# **A G E N D A**

## **Architectural Review Board**

**December 17, 2014**

2315 College Street

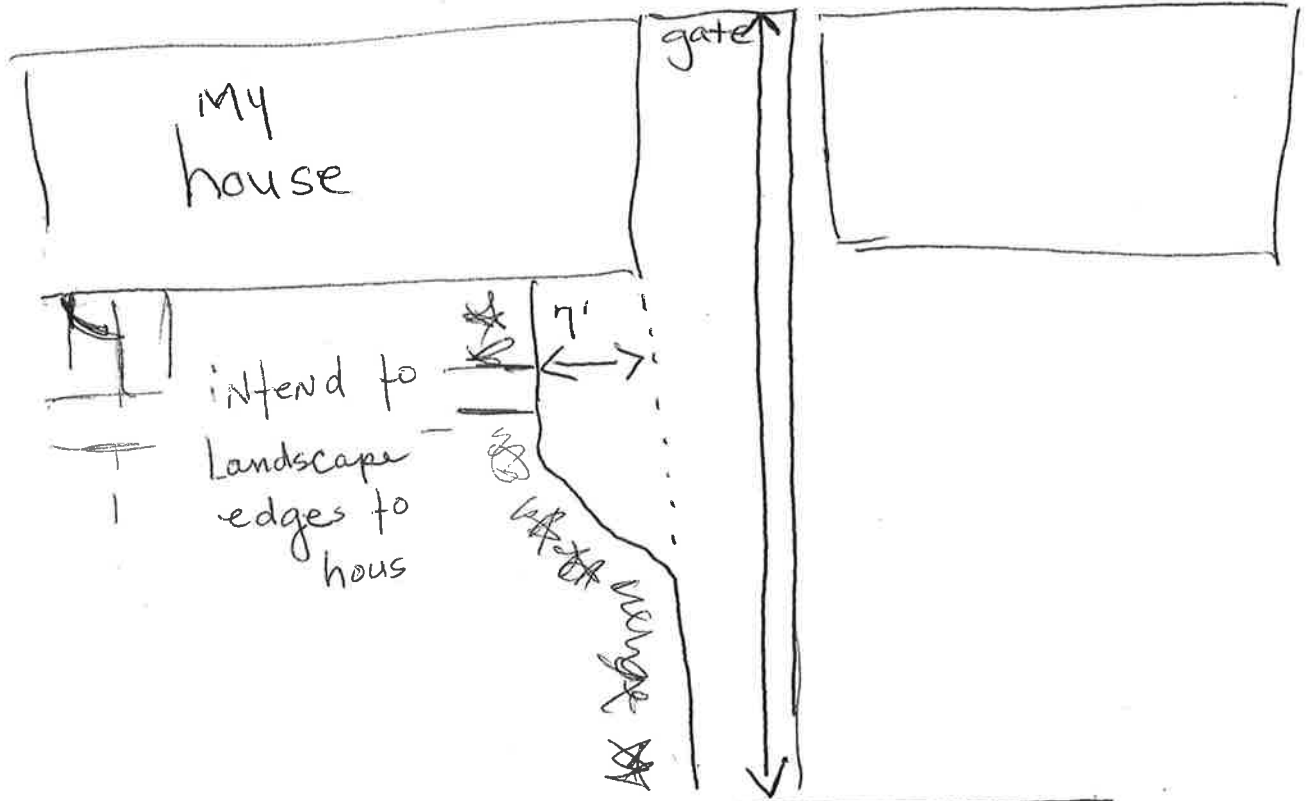
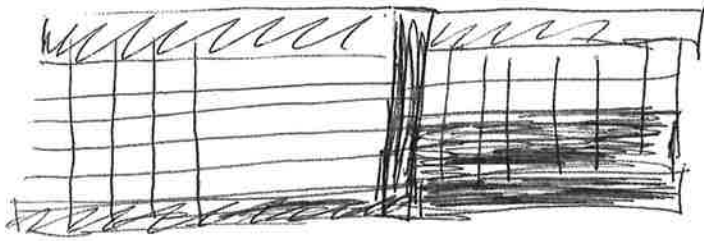
- Pea gravel had been approved for use in the pull off approved in September 2013.

642 Felder Avenue

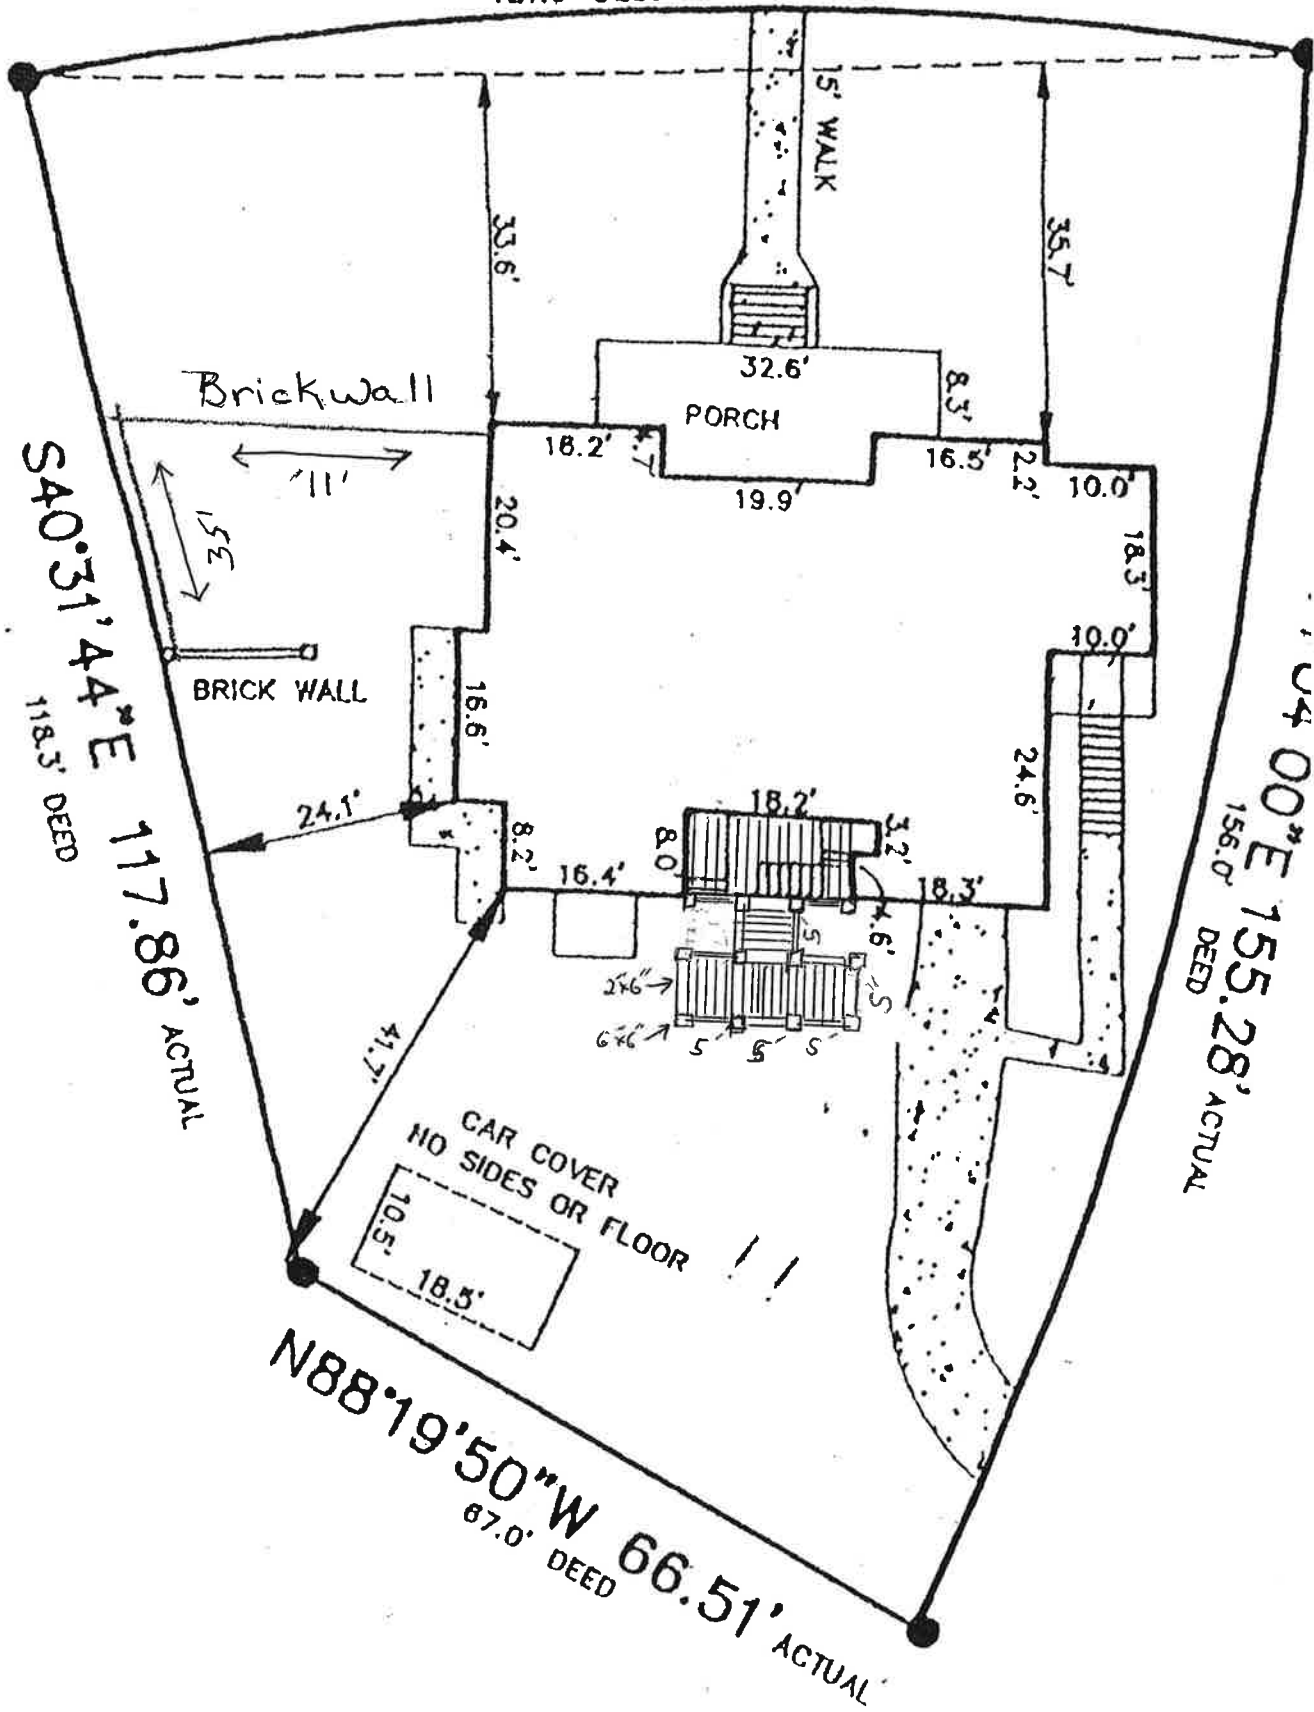
- The stairs are partially constructed, the Board needs to determine if the materials and configuration are appropriate and evaluate the project as though permission had been sought before construction. It does not fall to the Board to come up with a solution if the Board feels what has already been installed is not appropriate.
- This is a corner lot, and the rear yard is visible from Cloverdale Road.

SITE LANDSCAPE PLAN  
432 CLANTON AVENUE  
MONTGOMERY, ALABAMA

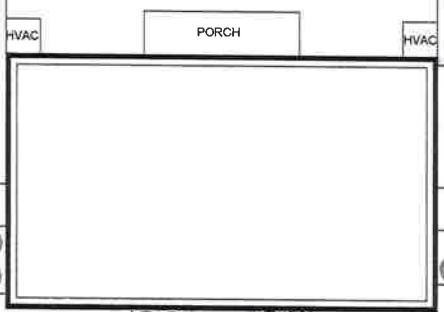
- Trees along the property line define the space and are appropriate for this lot. Several of the hackberry trees are less than 12" in diameter at the base, which is the threshold for ARB review.
- The application does not specify the materials of the new wall, staff recommends that the wall needs to be faced with brick (if constructed with another material), ideally using the brick being removed, to approximate the appearance of the wall that is there.
- Grading is a change that requires Board approval, the Board needs to determine if regrading the front lawn will drastically and negatively affect the appearance and setting of the building.

109/111 Felder Avenue

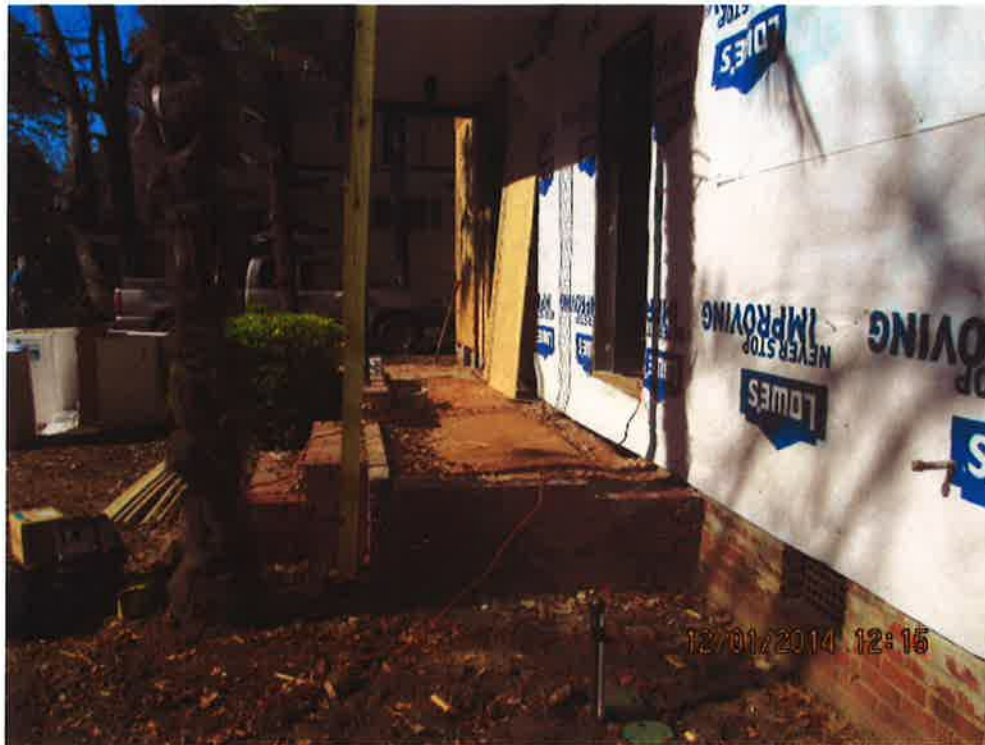
- Trees along the property line define the space and are appropriate for this lot.
- A textured Masonite siding is being replaced with a similarly textured and dimensioned material.
- 5/4" decking is not an appropriate porch material for a historic/original porch. The Board approved the use of decking with the 1x6 wrap as proposed for another project undertaken by Mr. Champion further down on Felder (photo included for reference), but that property did not have an extant covered porch that it was replacing. Because the porch landing was going to be exposed to the elements, the Board approved the decking in that situation.
